## Bolliger and Mabillard Flying Coaster

### SERVICE BULLETIN

FLYING COASTER

Driving wheels gearbox shafts

#### Detail of issue:

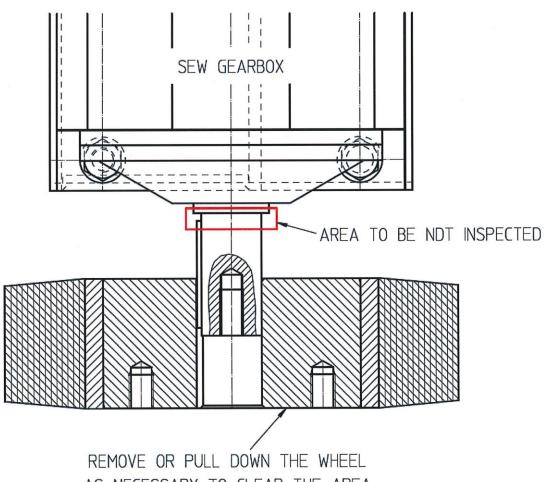
- NDT inspection (MT or PT) of gearbox shafts as per Detail of issue.
- Additional annual NDT inspection (MT or PT) of gearbox shafts as per Detail of issue.
- Additional close visual inspection of gearbox shafts at every wheel replacement as per Detail of issue.

- NDT inspection (MT or PT) of all driving wheels gearbox shafts of the station, transfer, lift base, brake and waiting areas within 30 days as per Detail of issue. (Maintenance area excepted)
  Replace the gearbox immediately if indication is found.
- Annual NDT inspection (MT or PT) of all driving wheels gearbox shafts of the station, transfer, lift base, brake and waiting areas as per Detail of issue. (Maintenance area excepted)
- At every wheel replacement, carefully clean the area and carry out a close visual inspection as per Detail of issue. In case of any doubt, proceed with a MT or PT inspection.

AS NECESSARY TO CLEAR THE AREA TO BE NDT INSPECTED
